**Land to the west of Chilgrove Drive, North of
Camp Road and adjoining former RAF Upper
Heyford, Upper Heyford incorporating former
MoD gymnasium: Planning Application
reference 14/02025/HYBRID**
Supplementary Transport Assessment

Final Report Revision A

Document short title Supplementary Transport Assessment

Figure: **6B**

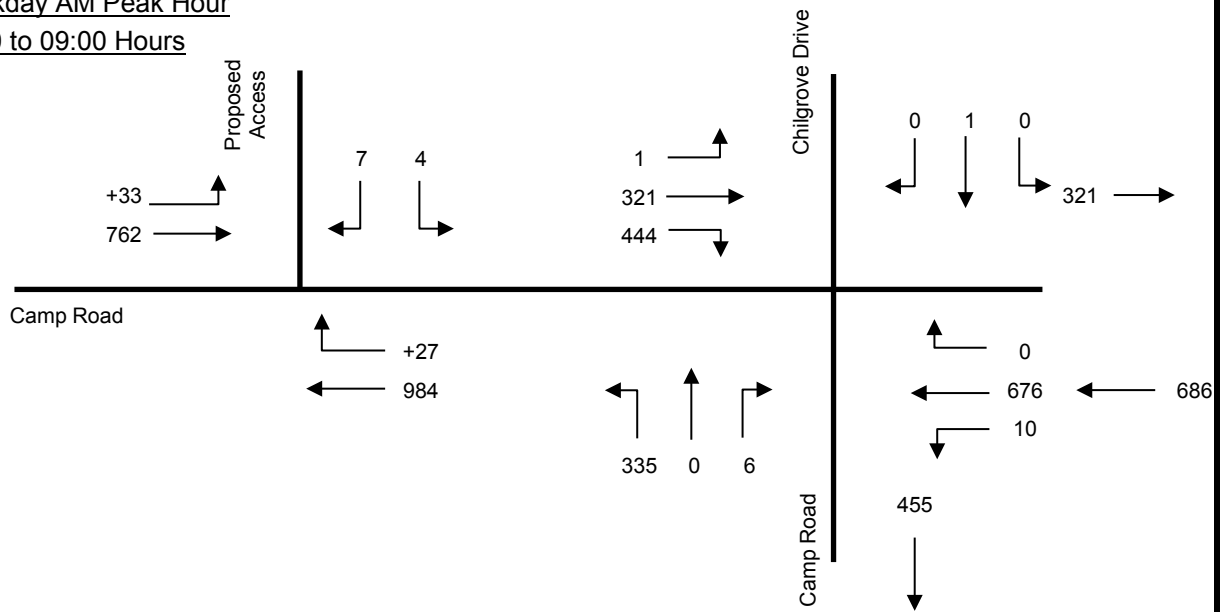
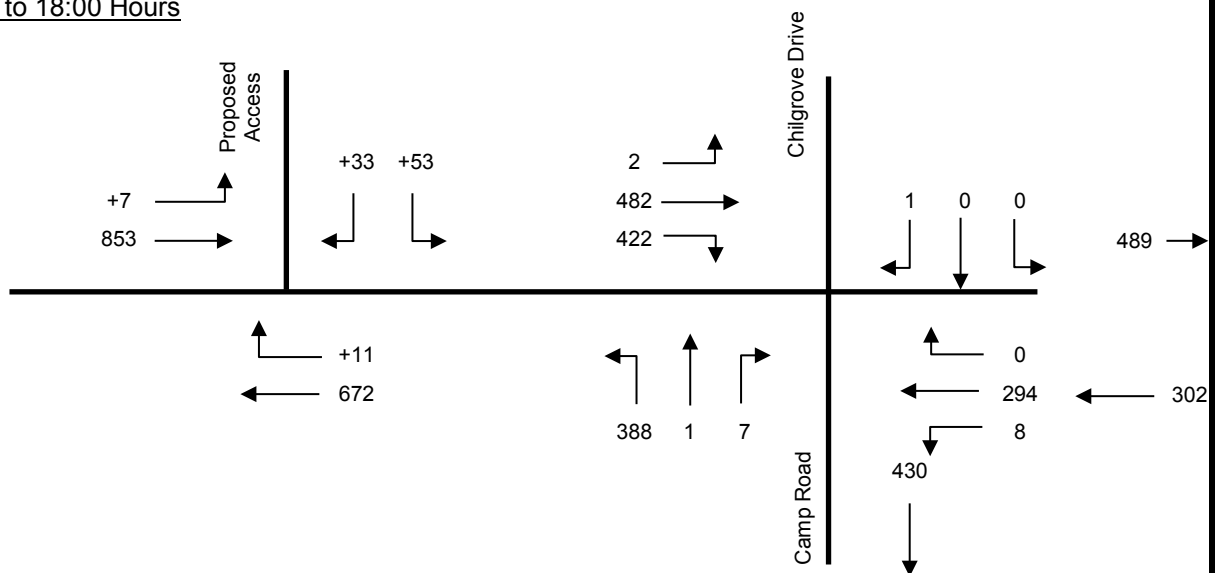
4.1.2 Provided at Appendix F (shown on Figure 6B) are details of the traffic flows used for analysis. These include the following: -

4.1.3 Consequently, the traffic figures provided at Appendix F are considered robust.
